Pumped hydro energy storage (PHES)

Andrew Blakers, Cheng Cheng, Anna Nadolny, Harry Thawley and Tim Weber

Australian National University RE100 group

We submit that there are substantial inadequacies in the draft 2024 PHES cost estimates:

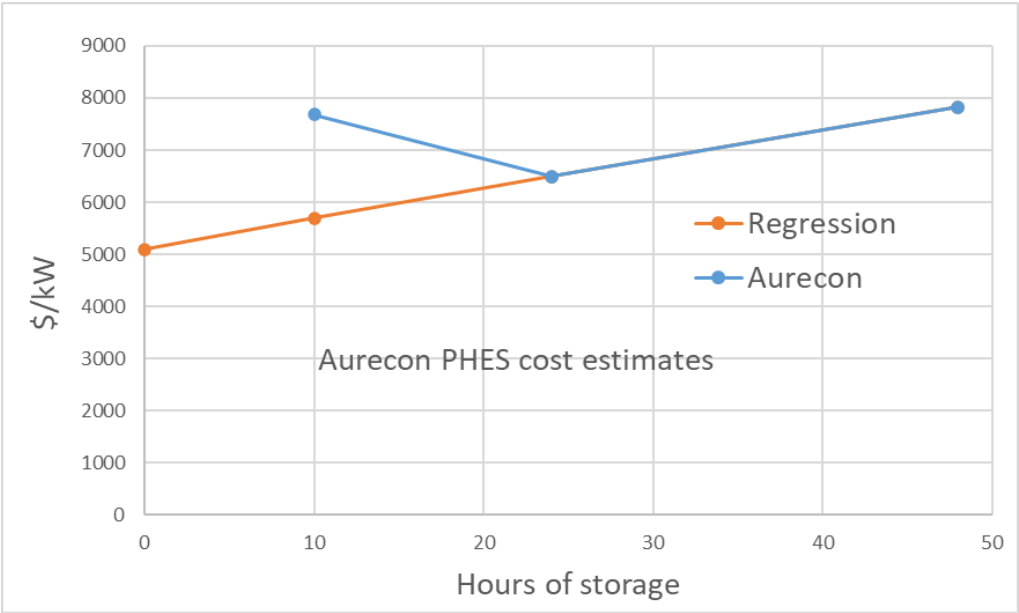
- d. It appears that Aurecon has modelled class A and class B sites **rather than Class AA like Dungowan**.
4. The 10hr, 24hr and 48hr costs are inconsistent as shown in the graph below.

- a. PHES 10hr should be cheaper than PHES 24hr for constant power capacity.
 - b. Furthermore, extrapolating the 24 and 48hr datapoints in the graph below to zero hours of storage suggests a PHES price excluding reservoirs of \$5100/kW. This is inconsistent with Snowy 2.0: Snowy 2.0 has a published price of \$5500/kW and there is zero reservoir cost (they already exist). However, Snowy 2.0 includes a very long (27 km) tunnel, which forms most of the total cost. Most Class AA sites in the ANU Atlas have tunnel length that is 4-10 times shorter (2-6 km); many can use aqueducts to further reduce tunnel length; and none are located in a remote alpine national park with

expensive roads, workcamps and transmission. This means that cost excluding reservoirs is far below \$5100/kW for consistency with Snowy 2.0.

- c. The imputed reservoir cost (comparing the 24hr and 48hr costs) is \$57/kWh which implies a Class A or Class B site rather than Class AA.

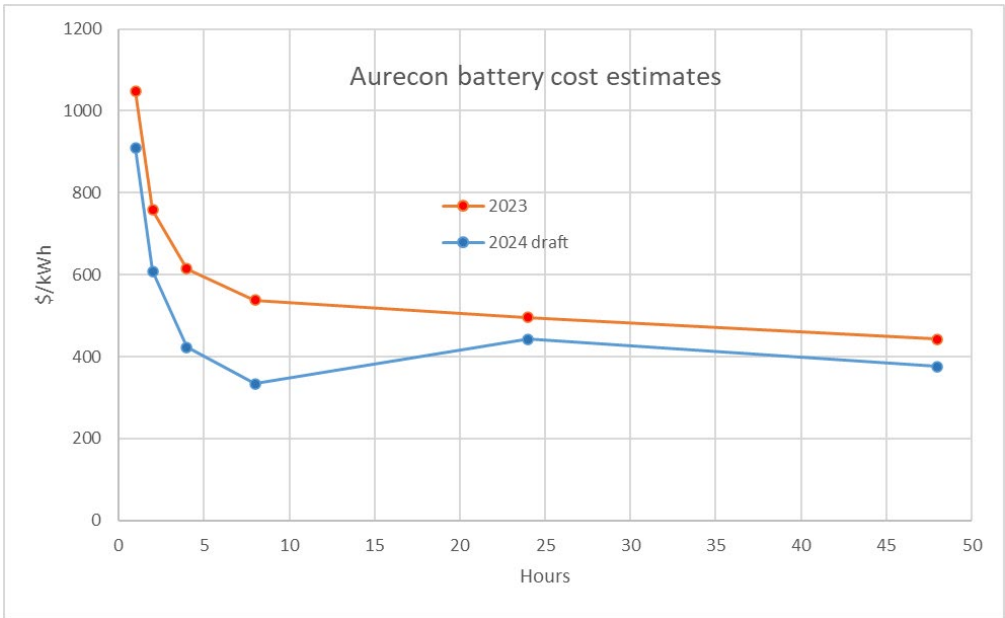
The cost estimates for batteries in the 2024 draft are inconsistent. The chart shows the 2023 and the 2024 (draft) estimates by graphing cost (\$/kWh) against hours of storage. Cost should decline continuously for larger-energy battery systems (assuming constant battery power).
